DOCKET	
01-AFC-24C	
DATE	DEC 21 2007
RECD.	DEC 31 2007

Subject: Public Health & Safety Complaint – Palomar Energy Center (Docket No. 01-AFC-24C)

Figure 1

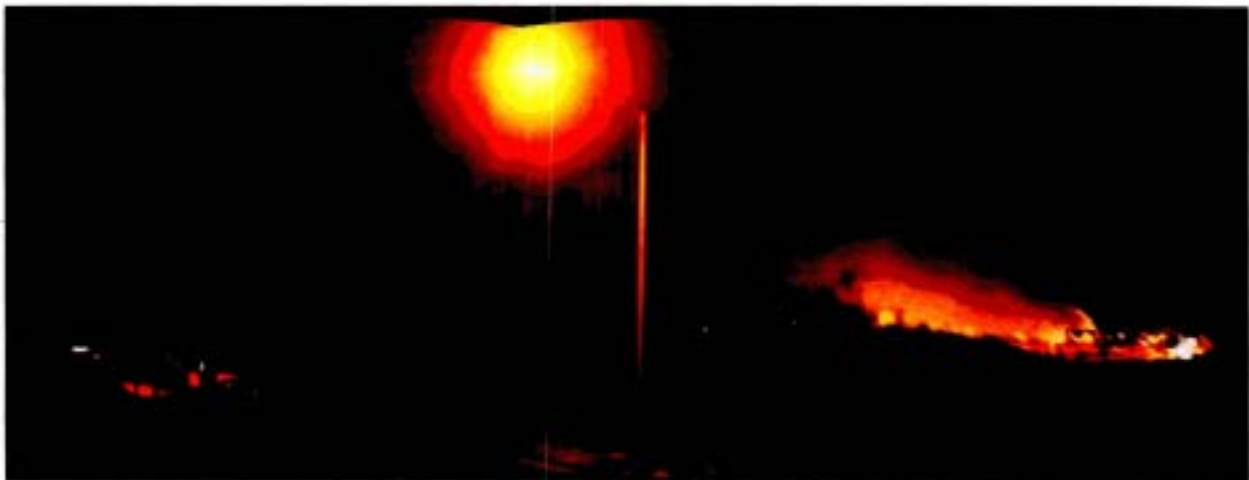
The California Energy Commission (CEC) staff analysis conducted for the Palomar Energy Center (PEC) improperly failed to take into account all conditions of operation of the facility and its impacts to the surrounding community and businesses has resulted in the project creating adverse impacts to public health and safety, nuisance and left cause for impacts in the area of aviation safety. Failure by both the CEC and the San Diego Air Pollution Control District (SDAPCD) to consider or conduct a comprehensive evaluation of airborne pathogens, including, but not limited to mold, viruses, and bacteria released from the operation of the cooling towers at the PEC puts the community and surrounding business at risk and has already created a Public Health issue. The need to properly examine impacts on the community and adjacent land uses, including impacts arising from increased airborne pathogens, contaminated moisture, particulate matter, health and safety and, the effects of the pathogens and other contaminants must take place to properly address impacts from an already flawed analysis done on this facility. Impacts to a nearby business and the noted increased respiratory problems to elderly residences are already documented impacts resulting from an environmental impact study and analysis already proving to be inadequate.
